Groundwater Sustainability Plan - Sustainable Management Criteria and Monitoring Network Chapters
Public Review Draft- Spring 2021
Compiled Public Comments, July 14 2021

Re: Comments to Draft Sustainable Management Criteria Chapter

Re: NOAA's National Marine Fisheries Service comments on the Draft Chapter 3 of the Groundwater Sustainability Plan for the Vina Subbasin

Groundwater Levels for Well 21N02E18C003M

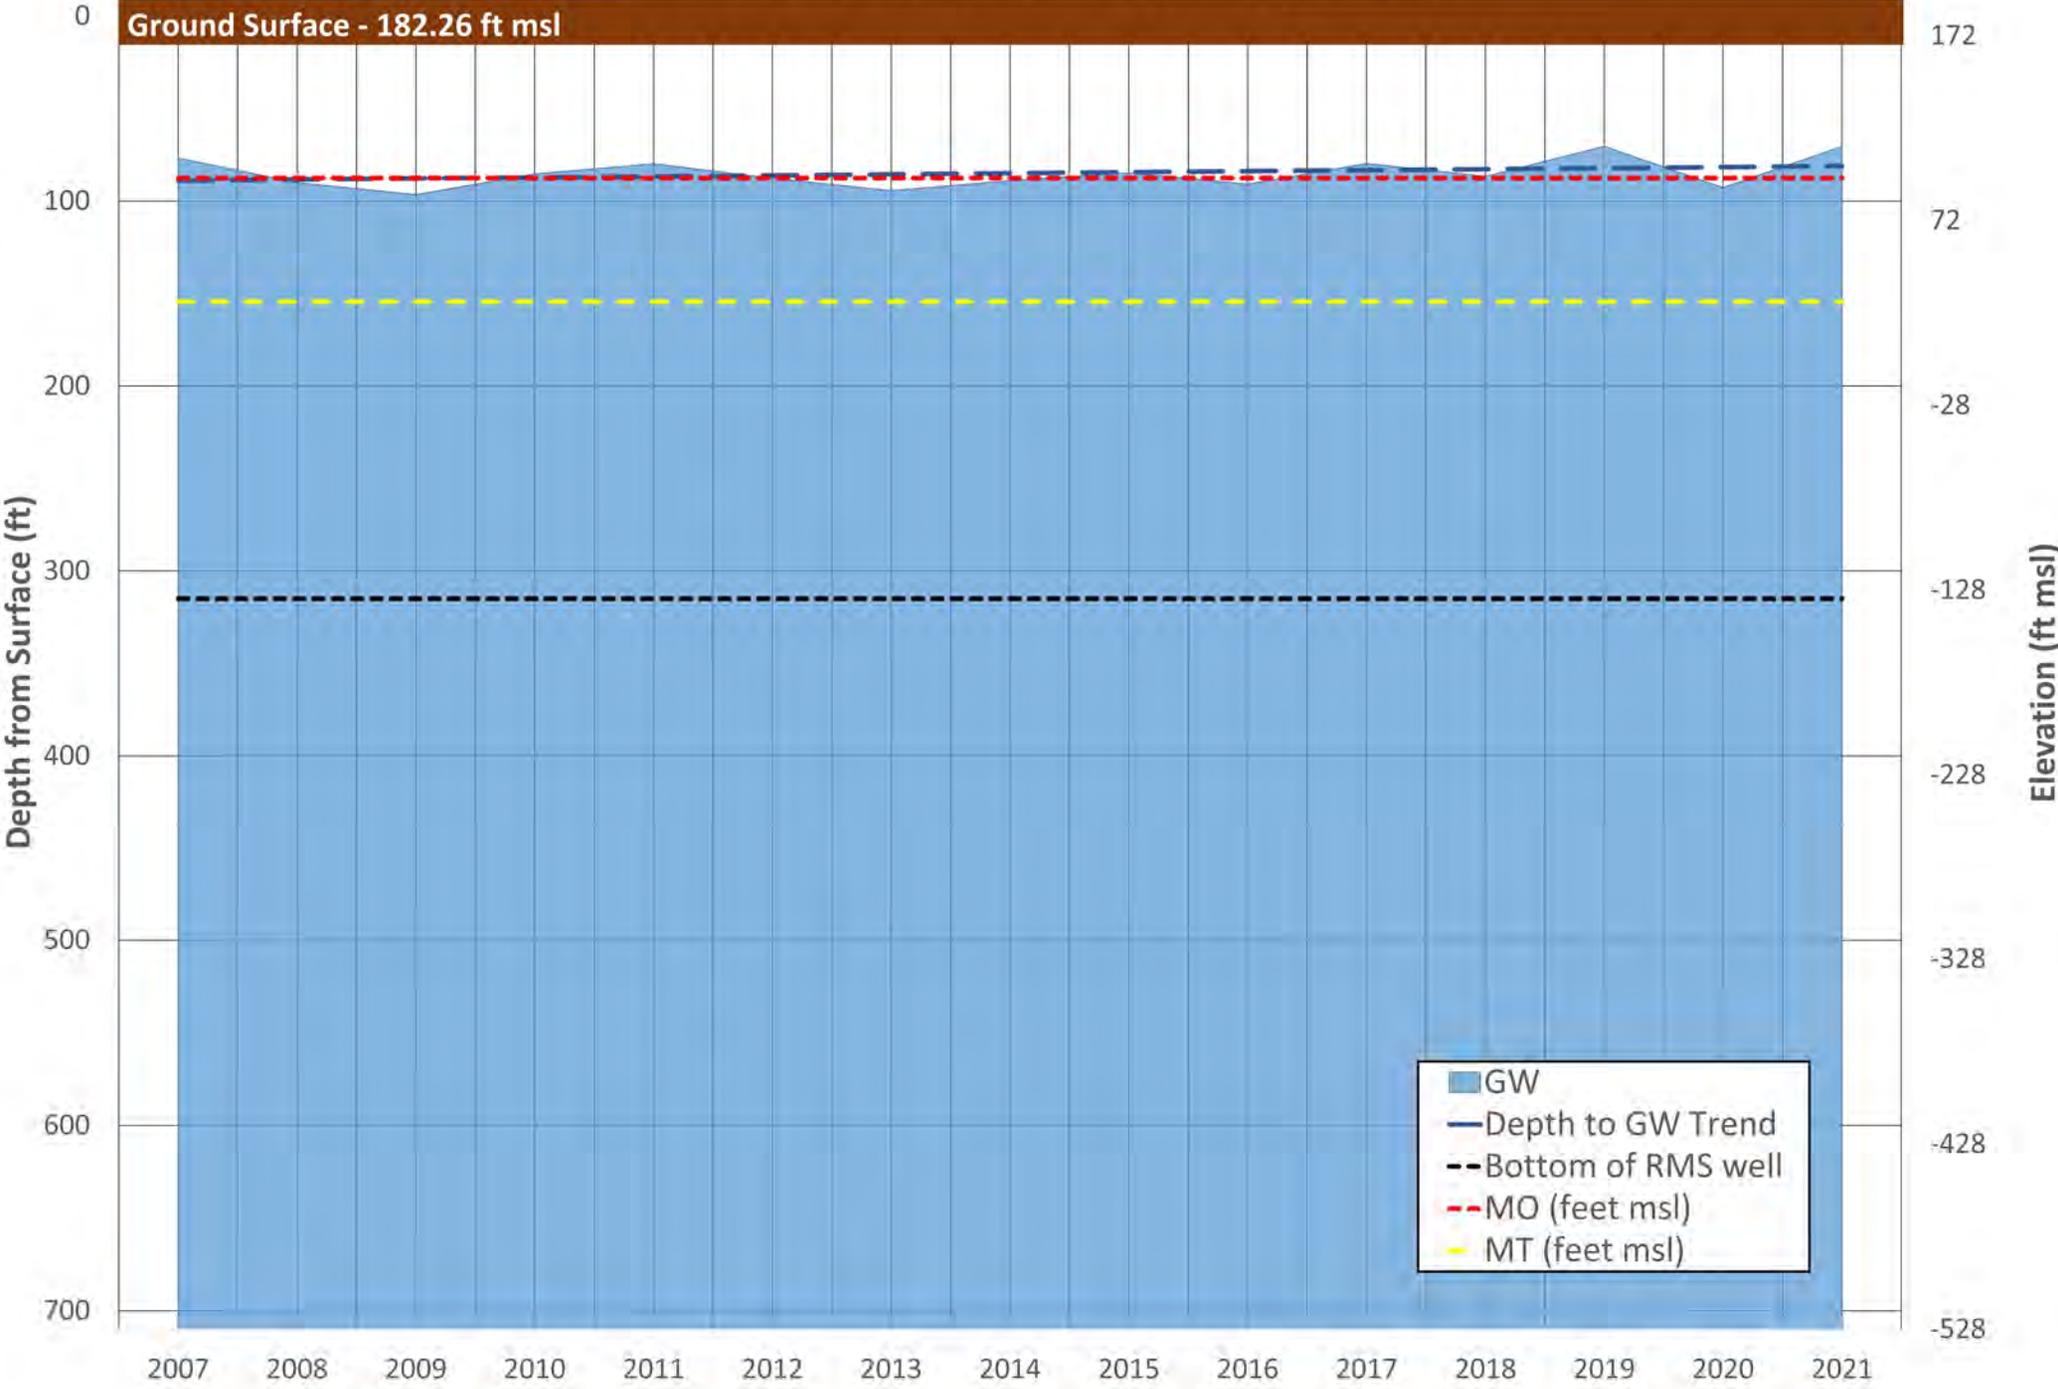
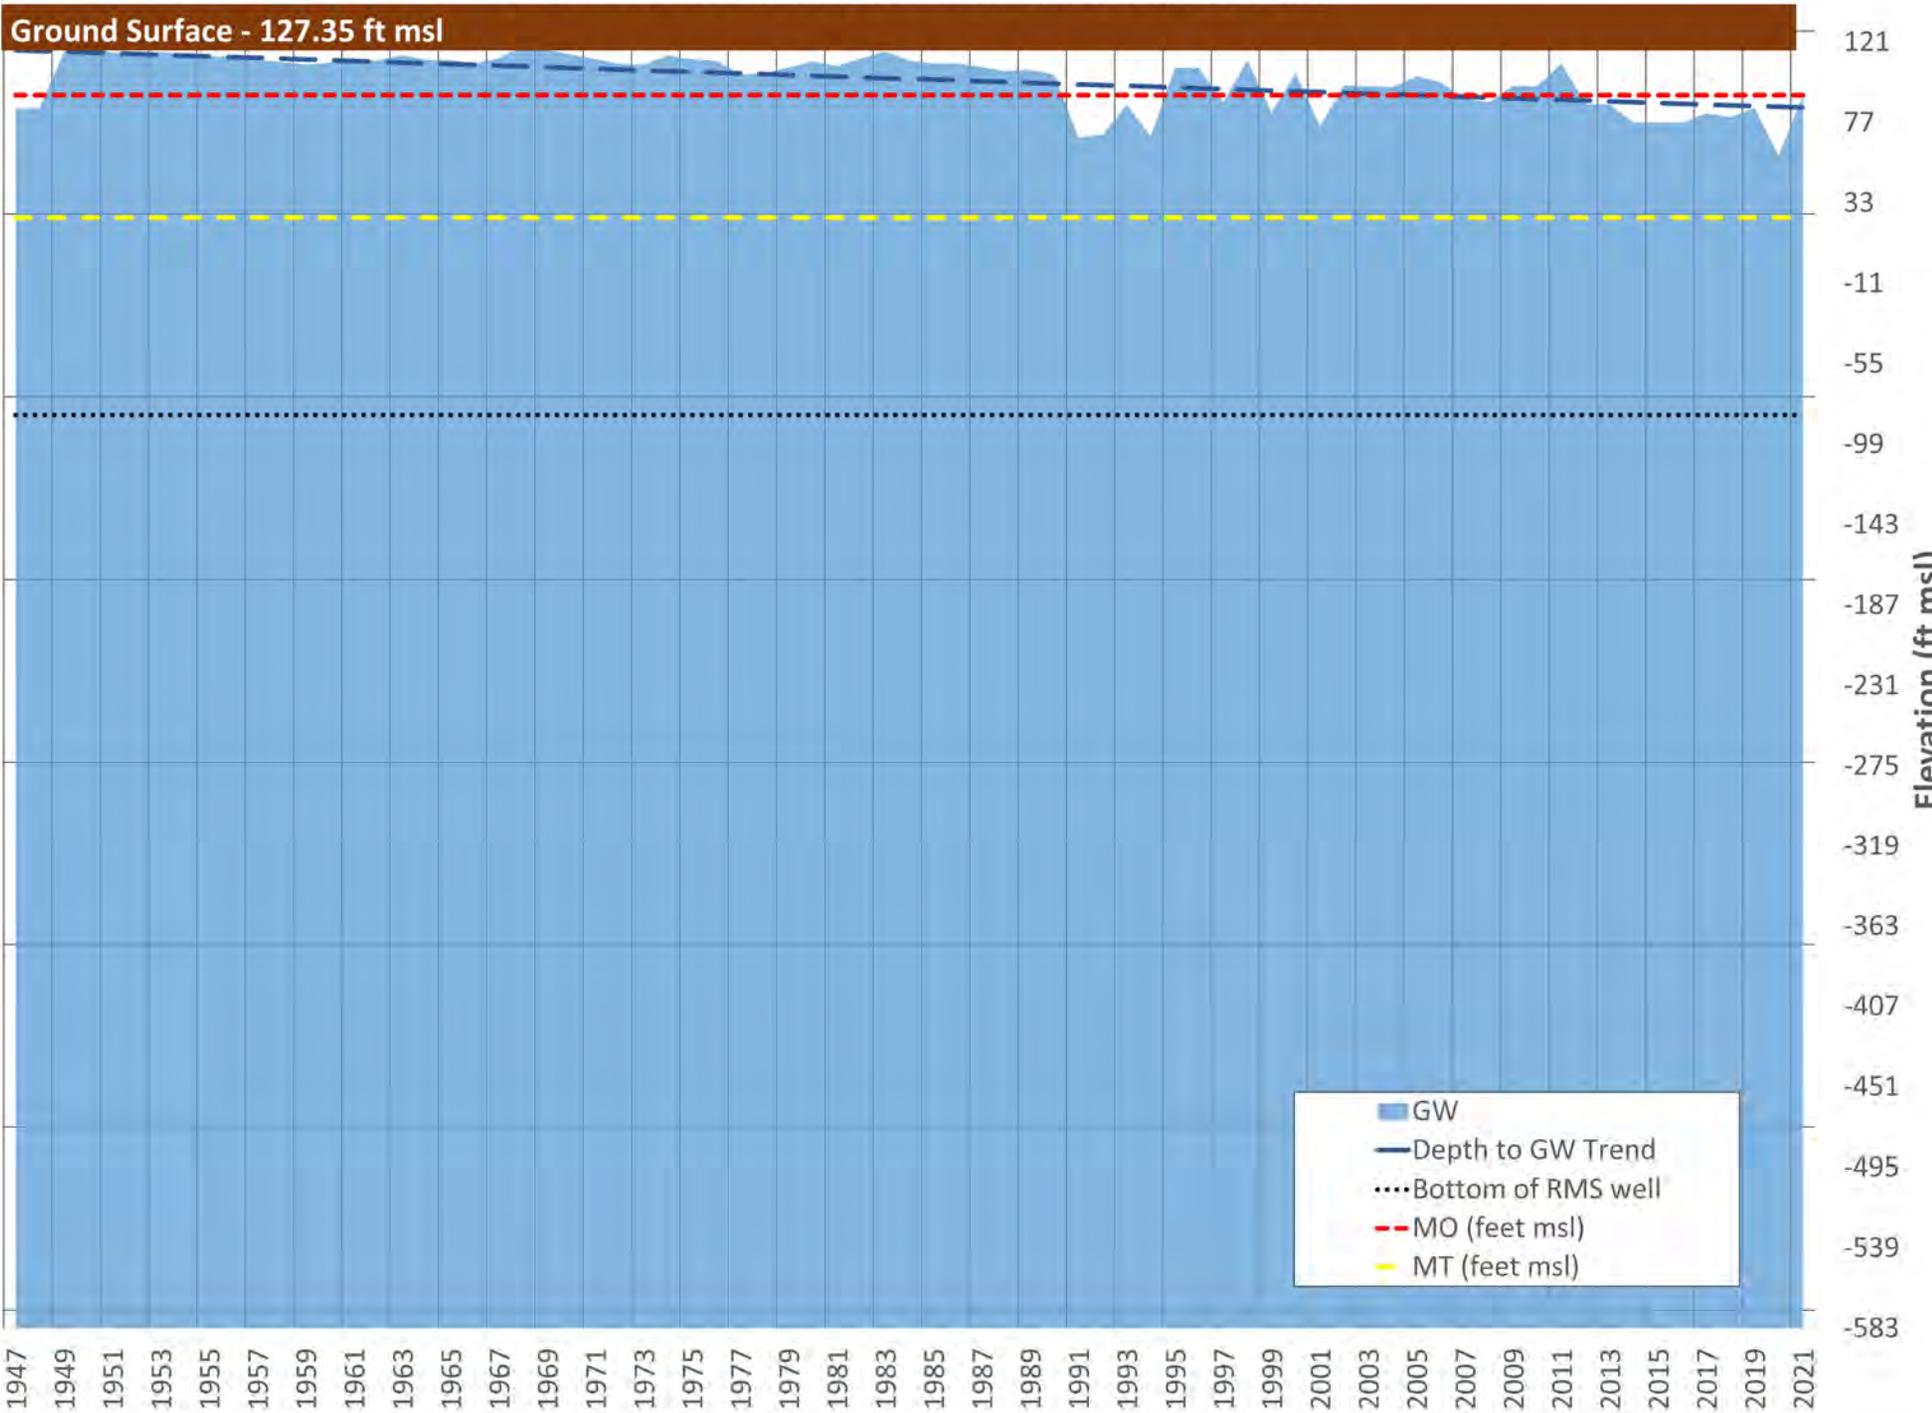
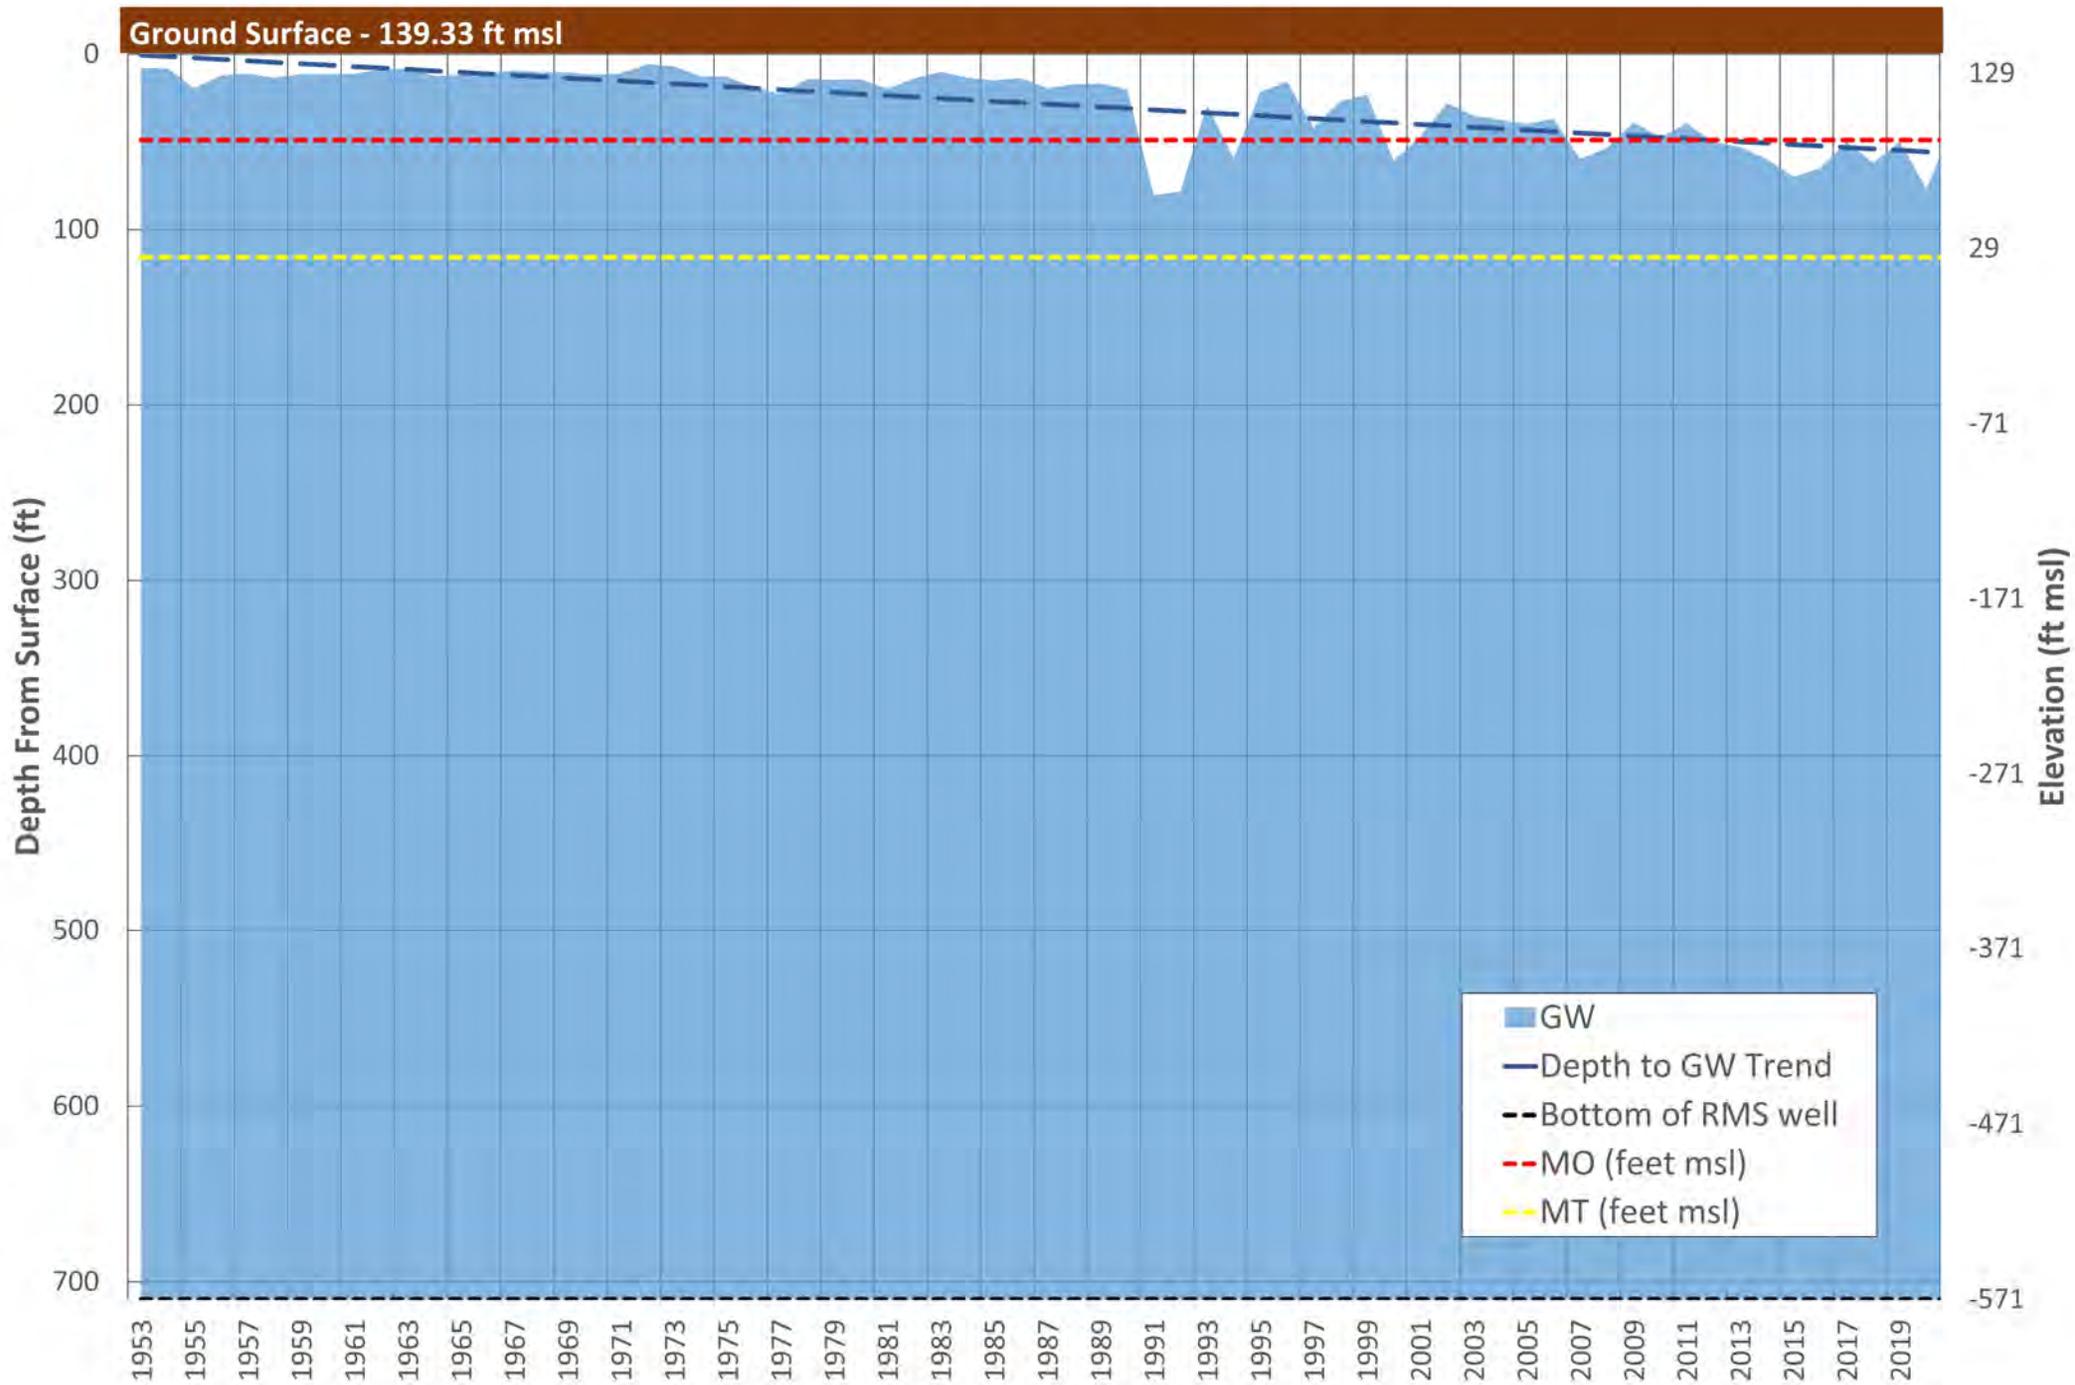
In recognition of the short timeframe to compile this information and meet the goal of the GSAs in getting the draft GSP out for public comment by September 2021, we hired Land IQ to propose polygons for the RMS wells in the Vina South Management Area. Enclosed is a map representing those polygons for the Vina South Management Area. You will find that a seventh zone is created as a result of this work.

The Margin of Operational Flexibility will need to be established for the polygon zones. As a starting point, we reviewed the Measurable Objectives (MO) and MT established for the Vina North Management Area and concluded that the average differential between the MO and MT was 67 feet. Consequently, the attached hydrographs for each RMS well (and polygon zone) show a difference of 67 feet between the MO and MT for the Vina South Management Area.
